Class II Permissive Change Cover Letter
SUBJECT: Class II Permissive Change for FCC ID : VSOXR-450

This is to request a Class II permissive change for FCC ID: VSOXR-450, originally granted on 12/16/2009. We changed the following points from the original model.

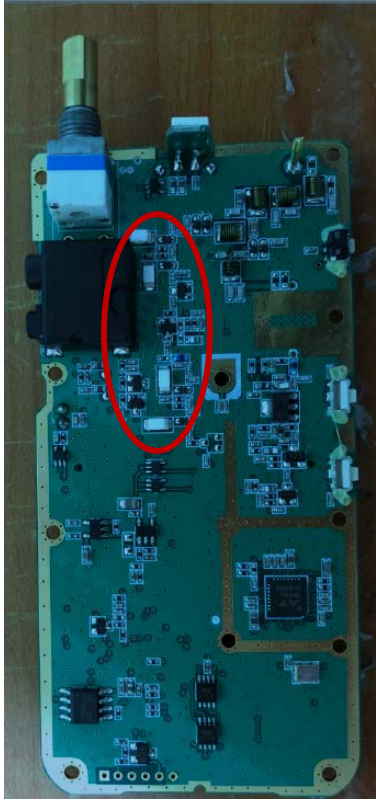
- Partial change of chips on the PCB board and single output due to software.
(Using software, adjust the frequency to match Part90 and delete 25kHz from channel spacing 12.5kHz and 25kHz. In addition, we used 2W and 5W, but deleted 2W as a program and used only 5W.)
- Meanwhile we submit the following documents related to this change. There is no change before and after change except for these documents.
